Intel Atom[®] Processor E3800

Specification Update

November 2019

Table 61. S4/S5 to S0 (Power Up) Sequence of the Intel Atom® Processor E3800 Product Family Datasheet, Doc #538136.

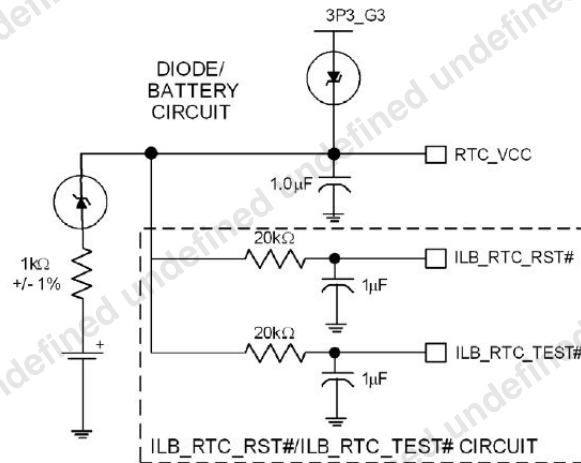
4. S4/S5 to S0 (Power Up) Sequence Specification Change

Note 5 from Table 61. S4/S5 to S0 (Power Up) Sequence of the *Intel Atom® Processor E3800 Product Family Datasheet*, Doc #538136, which specifies an alternate power-up sequence for the V1P0A & V1P8A rails, will be modified. The modified note will state:

These timings are allowed to have an error of up to 5%. When no max timing is specified, the actual timing should be as close to the min timing as possible under normal operating conditions (typically within one additional unit of time), but no max timing is guaranteed.
